Access Compliance Report Public Rights-of-Way (Curb Ramps)

Intersection ID: 10031496 Main Street: MCKEE_RD Cross Street: N/A Location: SE

ADA ID: BF008FDA9A92 Ramp Type: BlendTrans1 Initial Pass/Fail: Fail Overall Compliance: No Severity Score: 1.25

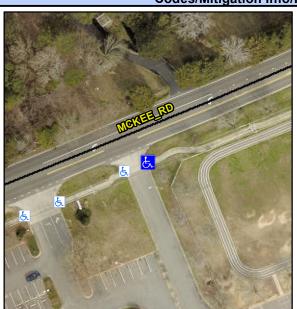
Field Measurements/Component Compilance					
Compliance Description		Data	Compliance Description		Data
N/A	Ramp Length (in)	70.0	Yes	BlendTrans Slope (%)	2.2
Yes	Ramp Width (in)	72.0	No	BlendTrans XSlope (%)	2.8
N/A	Flare Type LT	N/A	N/A	Flare Type RT	N/A
N/A	Flare Slope LT (%)	N/A	N/A	Flare Slope RT (%)	N/A
N/A	Flare Traversable LT?	N/A	N/A	Flare Traversable RT?	N/A
N/A	Landing Length (in)	N/A	N/A	DWS Provided?	N/A
N/A	Landing Width (in)	N/A	N/A	DWS Contrast?	N/A
N/A	Landing Slope (%)	N/A	N/A	DWS Length (in)	N/A
N/A	Landing X Slope (%)	N/A	N/A	DWS Full Width?	N/A
N/A	Landing Curb? (Y/N)	N/A	N/A	DWS Offset (in)	N/A
N/A	Shared Landing?	N/A			
N/A	Gutter Ponding?	N/A	N/A	Gutter Slope (%)	N/A
N/A	Gutter Lip Ht (in)	N/A	N/A	Gutter X Slope (%)	N/A
N/A	Painted X Walk1?	No	N/A	Painted X Walk2?	N/A
	X Walk 1 Direction	To SW		X Walk 2 Direction	N/A
	X Walk 1 Width (in)	N/A		X Walk 2 Width (in)	N/A
	X Walk 1 Slope (%)	1.8		X Walk 2 Slope (%)	N/A

Remove & Replace Curb Ramp With Two New Directional Ramps or Equivalent.

R304.5.3
